## **APPENDIX C – SCOPING LETTER AND RESPONSES**

The U.S. Army Corps of Engineers (Corps), Jacksonville District, is requesting your assistance in gathering information that will help define issues and concerns to be addressed in a Supplemental Environmental Assessment (EA) being prepared for the Canal 51 (C-51) West End Flood Control Project, Palm Beach County, Florida (enclosure 1).

RE Department of the Army, Jacksonville District Corps of Engineers – Scoping Notice –  
Supplemental Environmental Assessment for the Canal 51 (C-51) West End Flood  
Control Project – Palm Beach County, Florida.  
SAI # FL200408199221C

**SUBJECT:** Supplemental Environmental Assessment for the Canal 51 (C-51) West End  
Flood Control Project

Enclosure 2. Proposed modifications of the Levee 40 Borrow Canal (L-40BC)

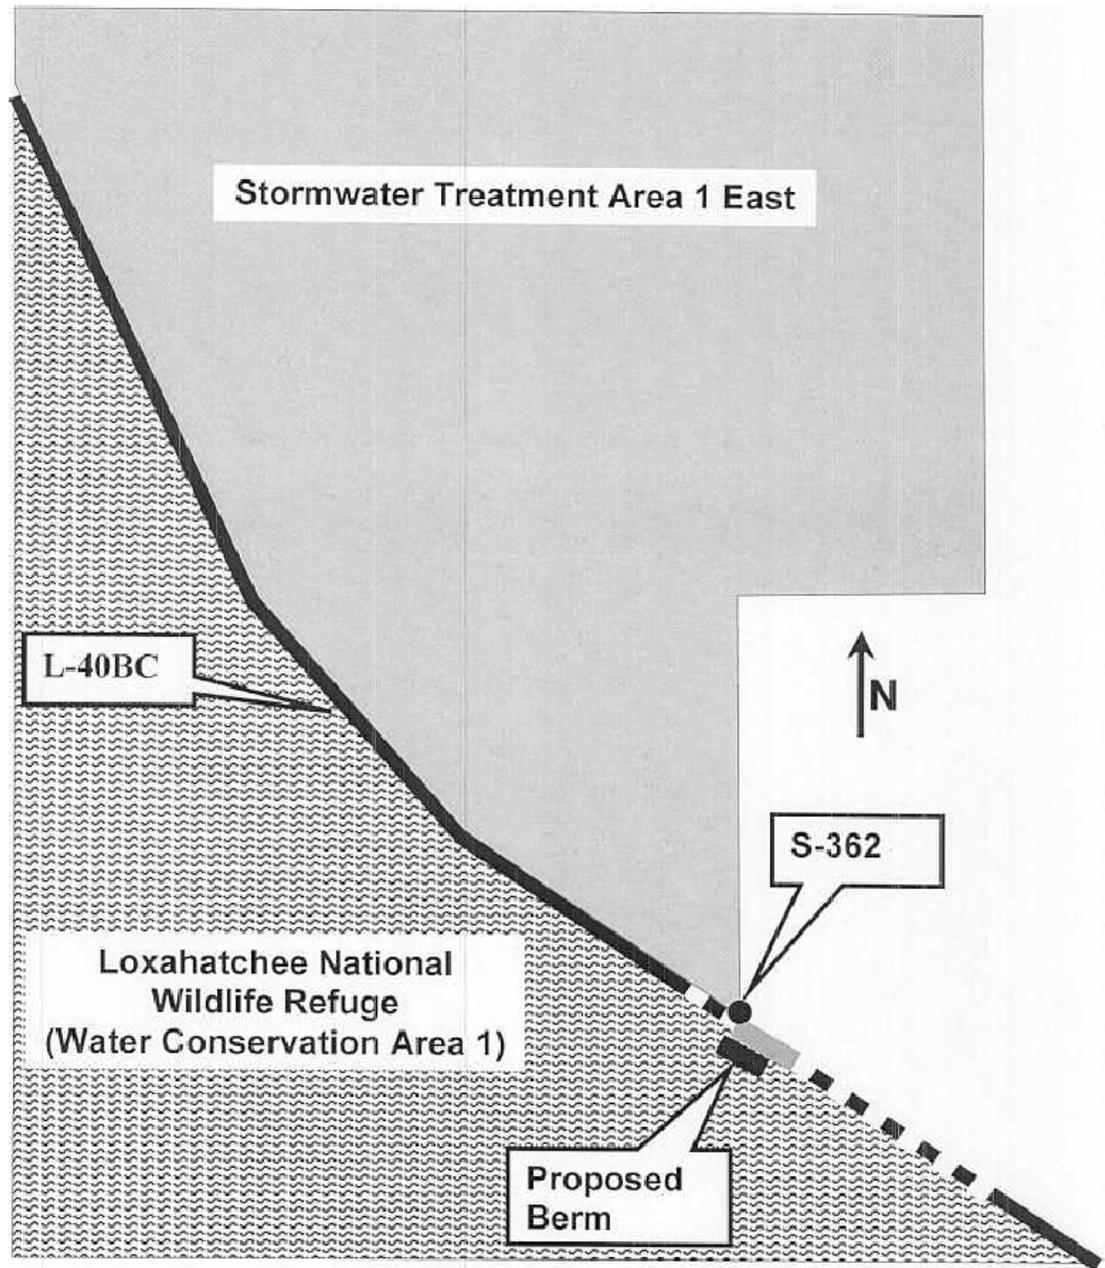
Our biggest concern at the June 1, 2004 meeting is the lack of technical foundation for the current option (#2). The request for input on this Supplemental EA does not provide any further detail design and therefore makes it challenging to accept the proposed design without further information. In light of the need to continue to move forward, we will support the current option (#2) provided that adequate water quality monitoring of the downstream marsh will be captured in the permit language and, if the monitoring reveals that the design is inadequate, a mechanism is put into place for timely action to be taken to resolve the problem.

The Department is very supportive of the conceptual work plan that has been presented for dredging and removing accumulated bottom muck material from approximately 8200 feet of the L-40 Borrow Canal, building a 1000-foot berm to protect the interior refuge at the location of the S-362 discharge canal, and widening a section of the L-40 near and just downstream of the new discharge canal. In developing the survey protocol and detailed design, the Corps should work closely with the Department, the Refuge, and South Florida Water Management District (SFWMD) staff to ensure that the final design is acceptable to all parties.

Please note that at this time it is difficult to provide comments on the proposed extent of dredging and filling, as detailed surveys have not yet been completed. Based on the information currently provided, we suggest the following:

- 3) We suggest that the scope of the survey of the project site be extended beyond the boundaries identified in the conceptual design to ensure that the project will be fully optimized.

- 6) The final project layout should be based upon site conditions where environmental survey data, topographic data, sediment samples, and core borings or sediment probes are utilized to determine the optimal design.
